## **Great North Road Solar and Biodiversity Park**

Draft Statement of Common Ground with National Highways

Document Reference – EN010162/APP/8.4BA

January-February 2026

Project:  
AADT CONSTRUCTION TRAFFIC FLOWS ON A1  
WORST CASE (100% Route North AND 100% Route South)

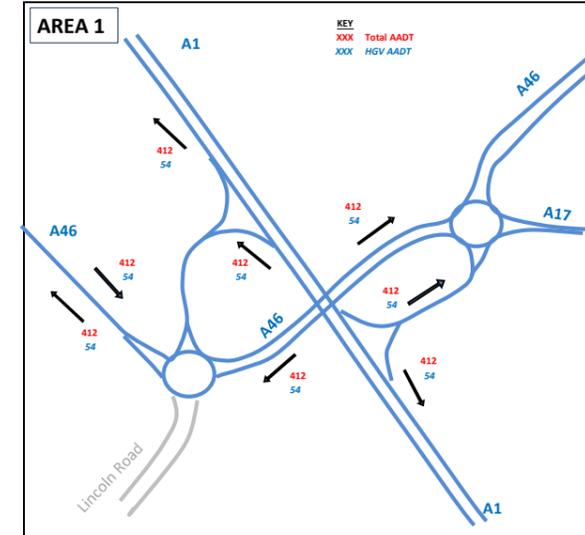
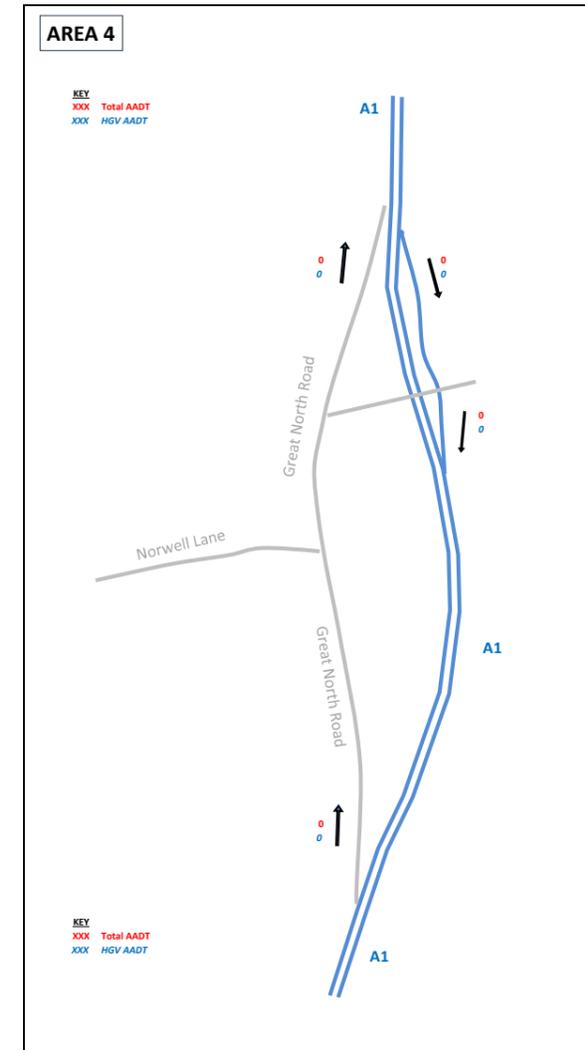
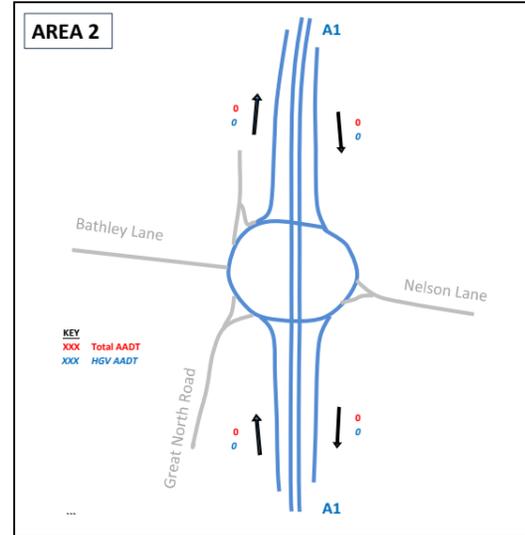
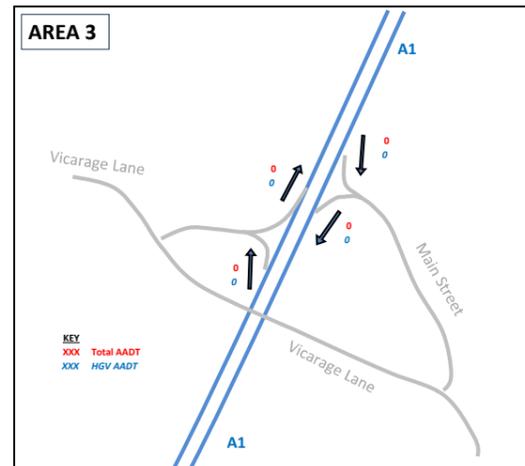
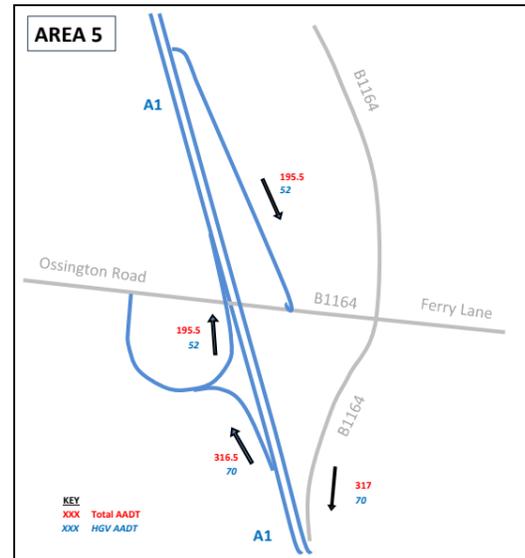
Month																		1	2	3	4	5	6	7	8	9	10	11	12	13	14	15	16	17	Trips on A1	0	12	20	26	6	10	10	11	11	11	7	4	1	16	28	36	8	<p>National Highways requests that the applicant provides details of the expected hourly traffic flow. This will enable National Highways to determine the potential impacts on the SRN, particularly during the typical AM and PM peak hours.</p> <p>Additionally, we note that core working hours are stated as 07:00 to 19:00 on weekdays. National Highways requests that further information regarding staff shift patterns and anticipated staffing levels be provided for our review.</p>	
	Month																																																										
	1	2	3	4	5	6	7	8	9	10	11	12	13	14	15	16	17																																										
Trips on A1	0	12	20	26	6	10	10	11	11	11	7	4	1	16	28	36	8																																										
2.1.5	WR	Trip Distribution	<p>Traffic flow diagrams for the junctions on the A1 were provided at Deadline 1. The flows presented are the AADT construction traffic flows on the A1, assuming a scenario whereby all traffic routes to/from the north and also, all traffic routes to/from the south. These diagrams will show the traffic flows currently presented in Appendix 1 of this SoCG. <b>NH Current Position:</b></p> <p>NH has reviewed the further information provided by the Applicant and is now content that the trip</p>	<p>National Highways requests that Traffic flow diagrams for the junctions on the A1 were provided at Deadline 1. The flows presented are the AADT construction traffic are provided for our review. When this has been provided, we will be in flows on the A1, assuming a better position to comment on the scenario whereby all traffic impact routes to/from the north and also, all traffic routes to/from the south. These diagrams will show the traffic flows currently presented in Appendix</p>	Under Discussion Agreed

Ref	Relevant Document	Description of Matter	<u>Applicant's National Highways' Position</u>	<u>National Highways' Applicant's Position</u>	Status
			<p>distribution is agreed. The additional information provided in the revised ES Chapter alongside the traffic flow diagrams provided at Deadline 1 provides clarity on the development proposals impact on the A1 and are deemed acceptable by NH.</p>	<p><del>1 of the proposed development</del> <u>this SoCG.</u></p>
